COUNCIL ASSESSMENT REPORT

SYDNEY WESTERN CITY PLANNING PANEL

Panel reference	PPSSWC-510
DA number	X/1578/2024
LGA	Blue Mountains City Council
Proposed development	Demolition of selected structures and tree removal; construction of a retail development comprising a full-line supermarket, separate retail tenancy, lower ground and rooftop parking, vehicular and pedestrian access, and associated landscaping; and a minor addition and external alterations to the Oriental Hotel
Street Address	110–112 Macquarie Road Springwood 2777 & 8–12 Raymond Road Springwood 2777
Applicant	FABCOT PTY LTD
Owner	Mrs D H Wayne J P Benson Pty Ltd Springwood Oriental Pty Ltd
Date of DA lodgement	10 December 2024
Submissions	402 total unique submissions, including 212 objections, 187 in support, and 3 with questions/comments
Key issues raised in objections	Character impacts, economic impacts, traffic impacts, and noise impacts
Recommendation	Approval
Regional development criteria	Clause 2, Schedule 6 of <i>State Environmental Planning Policy (Planning Systems) 2021</i> (Development with estimated development cost >\$30 million)

Figure 4: Sketch showing potential future removal of 1960s addition (Source: Nettletribe, annotated by Council officers)

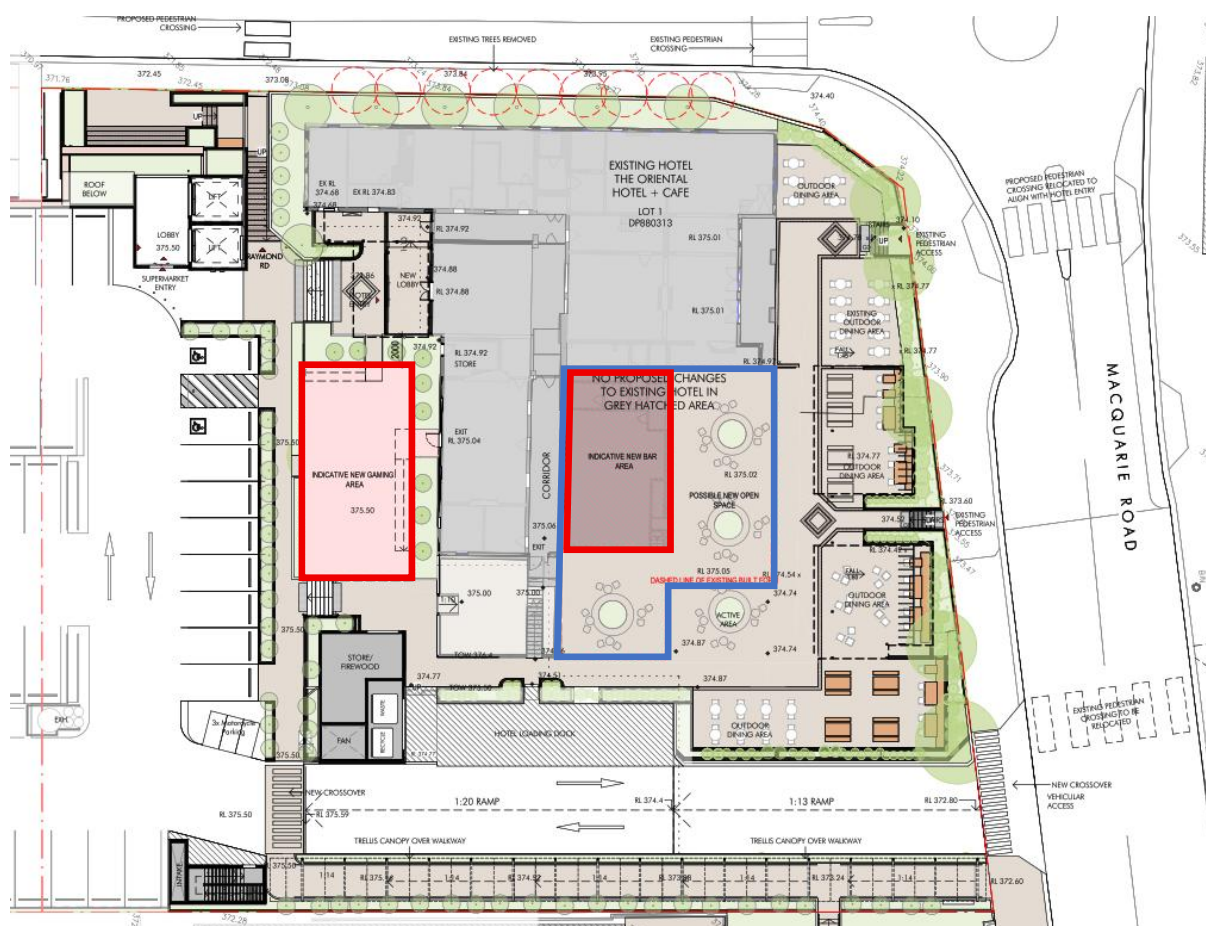
It is disappointing that the applicant has not taken up the opportunity identified in the CMP to remove or modify the 1960s addition to reveal original heritage fabric. The current proposal may be the best chance to act on that opportunity for the coming 25+ years. Nonetheless, Council officers accept that the applicant does not wish to remove or significantly alter the 1960s addition at this stage. The applicant has instead provided a basic sketch (see **Figure 4** below) demonstrating how a pavilion-style addition behind the hotel and a small sympathetic addition at the front of the hotel could be constructed to accommodate the uses in the 1960s addition should the addition be removed in the future.

To ensure a future addition is feasible and constructable, a condition has been drafted requiring further detail as to how the belowground supermarket structure and services are designed to accommodate the future addition.

Furthermore, to ensure the area behind the hotel is indeed reserved for the purposes of facilitating removal of the 1960s addition, a condition has been drafted to require a restriction to be registered on the land title. The restriction will prohibit construction of any building in the reserved area unless the building forms part of a development to remove the intrusive 1960s additions. Removal of the intrusive additions is an extremely important goal for promoting the heritage significance of the hotel and conservation area, and the condition requiring the restriction on title will ensure this goal is recognised and taken seriously by the existing and future owners of the property.

Figure 5: Required changes to pedestrian infrastructure (Source: Nettletribe; modified by Council officers)

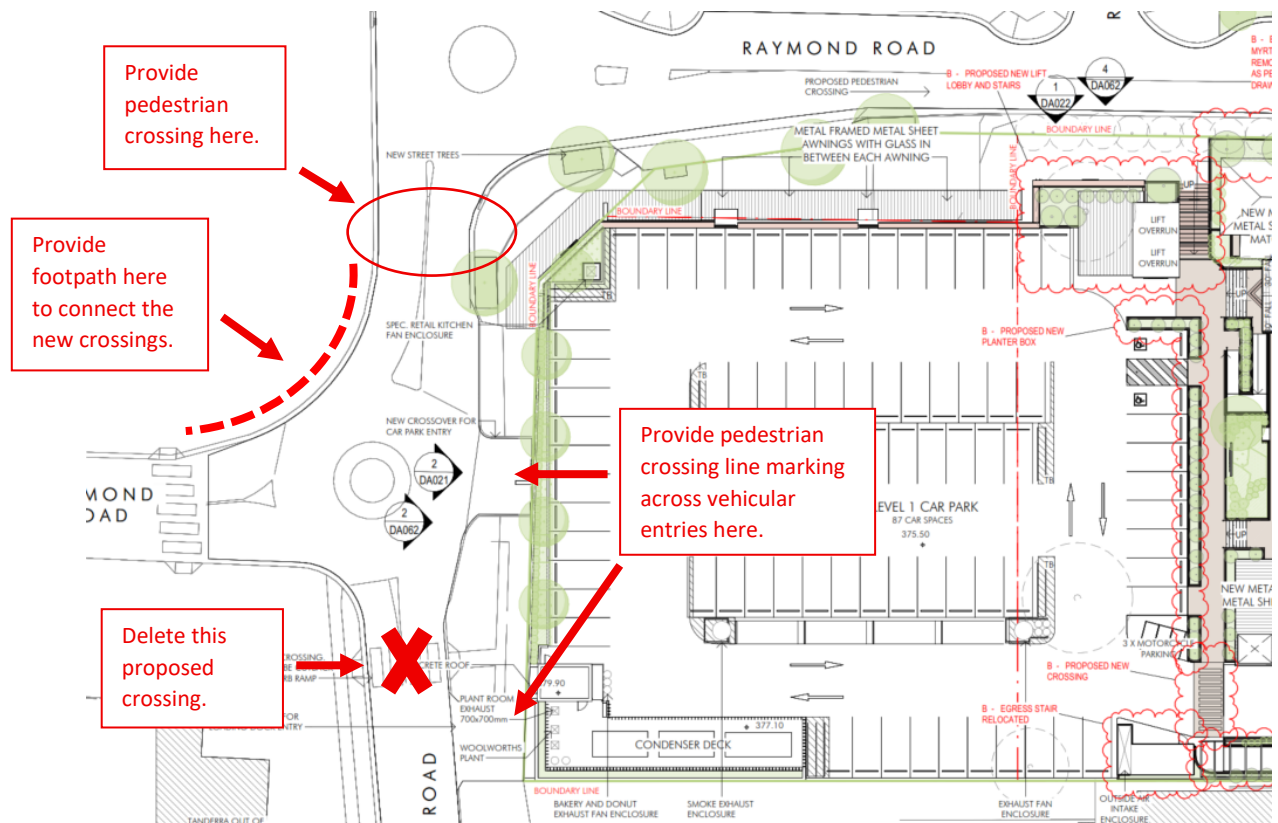
- Pedestrian line-marking must be provided across the vehicular entries on David Road to improve pedestrian safety. See **Figure 5** below. Many submissions expressed concerns about conflicts between cars and pedestrians at this location.

- A pedestrian crossing must be provided on David Road between the existing and proposed roundabouts. See **Figure 5** below. This location will more closely align with the pedestrian 'desire line' between Raymond Road and the town centre. Provision of this crossing means that the proposed to the east of the new roundabout is not required.

- A footpath must be constructed along the southwestern side of the new roundabout to connect the two pedestrian crossings. See **Figure 5** below. As noted above, this route of travel more closely aligns with the natural pedestrian 'desire line' and avoids the need to cross two vehicular entries when walking between the town centre and the southern section of Raymond Road.

Figure 6: Required widening of pedestrian link (Source: Nettletribe; modified by Council officers)

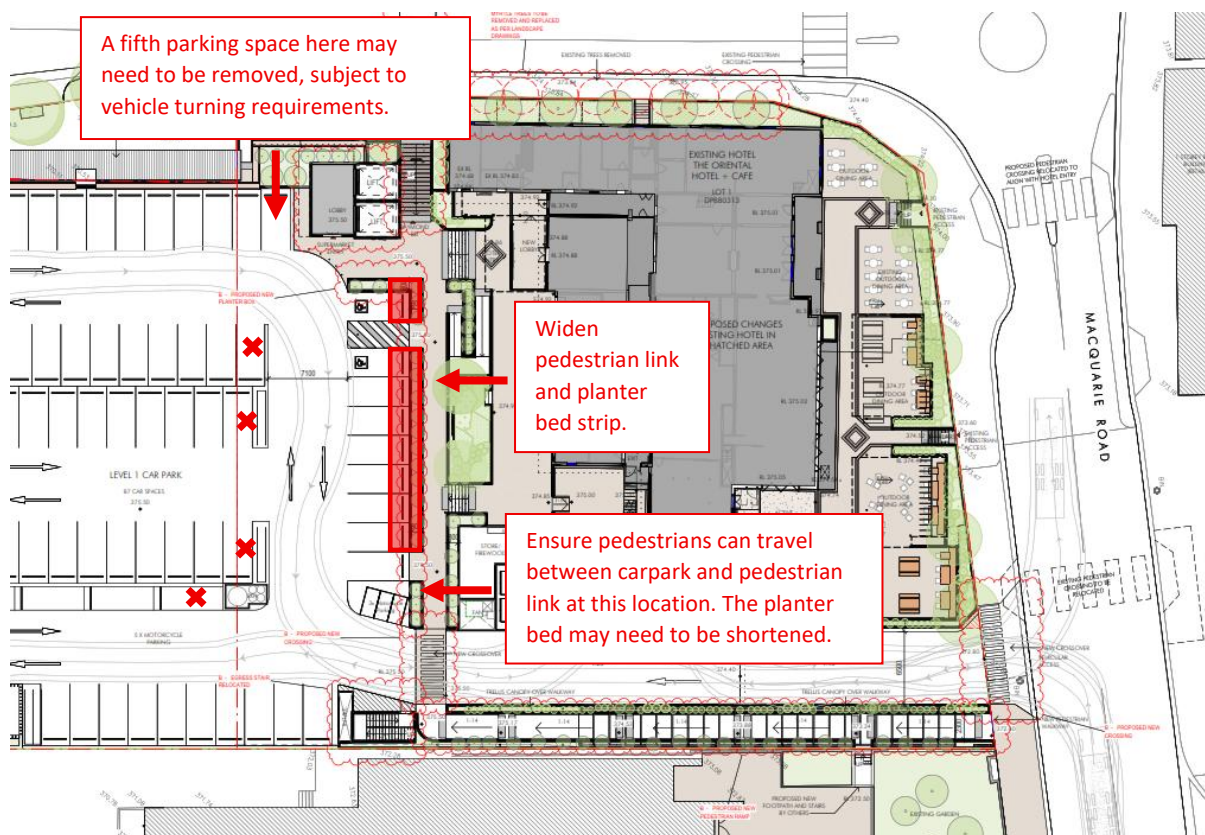
- The east–west pedestrian pathway and adjacent planter bed across the Level 1 carpark should be widened. The pathway is approximately 2.2m wide, and there is an 800mm wide planter bed between this pathway and parking spaces. The combined pathway and planter bed should be widened by at least 2.4m (i.e. the approximate width of a parking space), with the planter bed to be at least 2m wide. Additionally, the planter bed immediately to the north of the motorcycle parking spaces should be shortened slightly to provide space for pedestrians to walk from the carpark to the east–west link. These changes are identified in **Figure 6** and captured in a recommended condition of consent.

The benefit of this amendment is substantial and the cost low. The benefits are increased pedestrian amenity along the northern edge of the carpark (including a wider walkway and denser and more robust plantings in the planter bed strip) and additional separation between the carpark and Oriental Hotel, which will increase the curtilage around the heritage item and allow for more flexibility in the future should a pavilion-style building be constructed behind the hotel as part of removal of the intrusive 1960s additions.

The cost is removal of up to 5 parking spaces (1 at the end of each centre aisle, 1 parallel space in the centre aisle, and potentially 1 space adjacent the lift lobby). The applicant has expressed a strong preference not to reduce parking quantity for commercial reasons. Nonetheless, Council officers are satisfied—as discussed in as discussed in Section 3.3.4 of this report—that the development will provide sufficient parking even accounting for this amendment.

Figure 7: Public domain area to be enhanced (Source: Nettletribe; modified by Council officers)

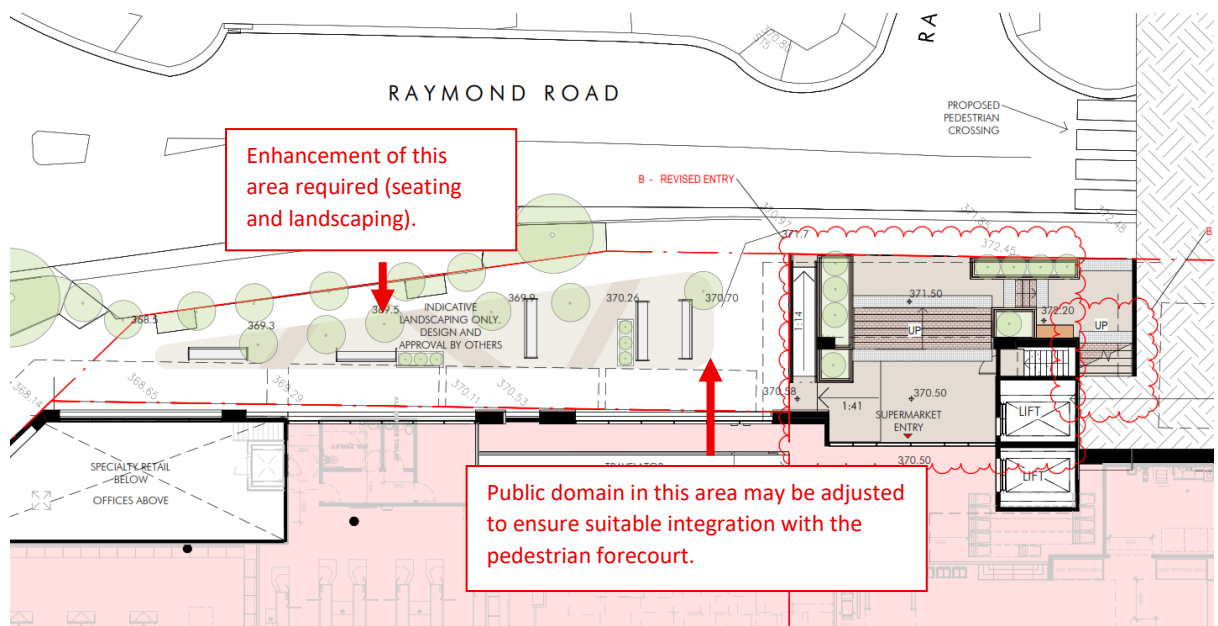
- Landscaping and seating must be provided in the wedge-shaped public domain area immediately to the south of the pedestrian entry, as marked in **Figure 7**. Council officers have recommended a condition of consent accordingly. This approximately 230m² area currently features a vehicle crossing (to be removed) and a wide footpath.

While the submitted plans show indicative landscape works (seats and plantings) in this area, they note that the design and approval for these works are 'by others'. However, it is common and expected for major developments in town centres—especially developments subject to design excellence provisions—to deliver improvements to the public domain immediately adjoining the site, at the developer's expense. The proposal will attract high foot traffic and introduce a new (larger) built form at the site.

The required enhancements will ensure safe and convenient pedestrian movement, soften the built form, and deliver public benefit commensurate with the scale and significance of the development.

In addition to seating and landscaping, the applicant must ensure the treatment to this area integrates appropriately with the entry forecourt area in terms of finishes and levels. Adjustments to the levels in the public domain may be allowed.

Figure 8: Required landscape amendments (Source: Site Image; modified by Council officers)

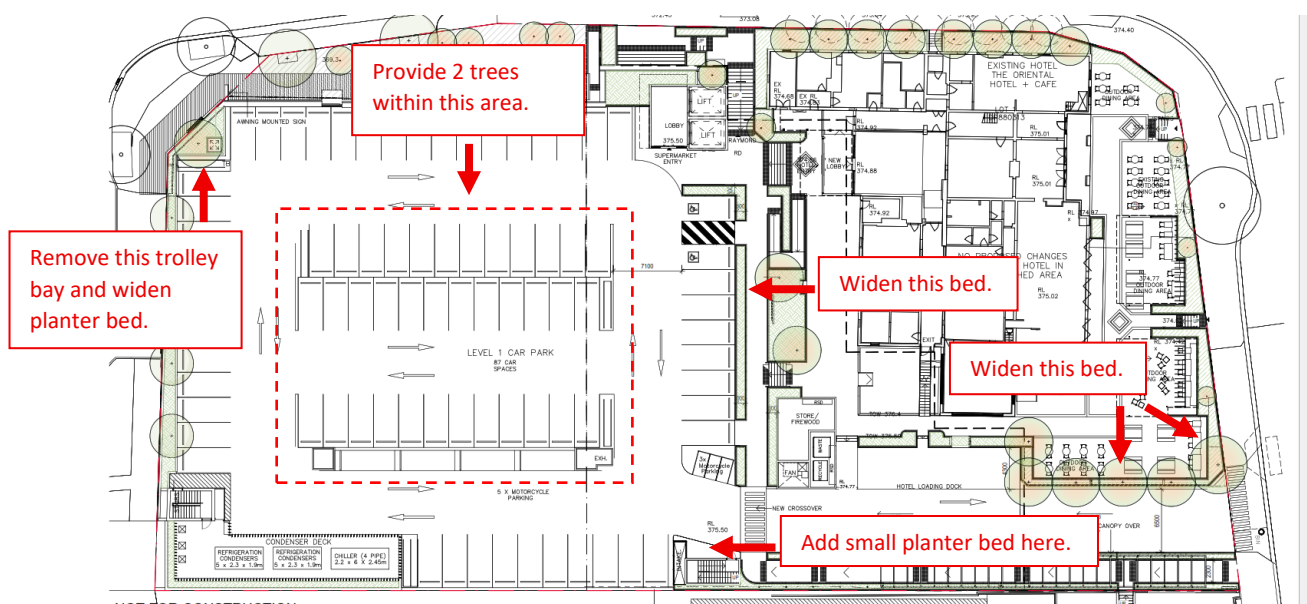
- Tree 3 and Tree 4 are to be retained and incorporated into the landscape scheme, as discussed in Section 3.3.9 of this report.
- The planter bed along the northern edge of the carpark is to be widened as discussed in Section 3.3.5 of this report and shown in **Figure 8**.

- A small planter bed is to be added in front of the air intake at the top of the Macquarie Road driveway. See **Figure 8**. While this change may seem minor, Council officers consider, given the absence of shade structures and the generally marginal nature of the carpark plantings, that even small areas of additional rooftop landscaping are worthwhile.

- The trolley bay to the east of the specialty retail shop kitchen exhaust is to be removed, and the adjacent planter bed extended to occupy its place. Council officers consider that removal of the trolley bay will not cause any serious adverse impacts to supermarket operations or customer amenity. See **Figure 8**.

- The addition of 2 trees in raised planter beds within the middle parking area, with 2 parking spaces to be removed to accommodate these trees. See **Figure 8**. In the absence of any rooftop shade structures, it is reasonable to require tree plantings within the carpark at the expense of parking. The trees will improve visual amenity, provide at least some shade, and align with Section F2.3 of the DCP, which requires new advanced trees in carparks where existing trees cannot be retained.

- Change the rooftop carpark circulation to one-way, and incorporate any surplus circulation space into planter beds.
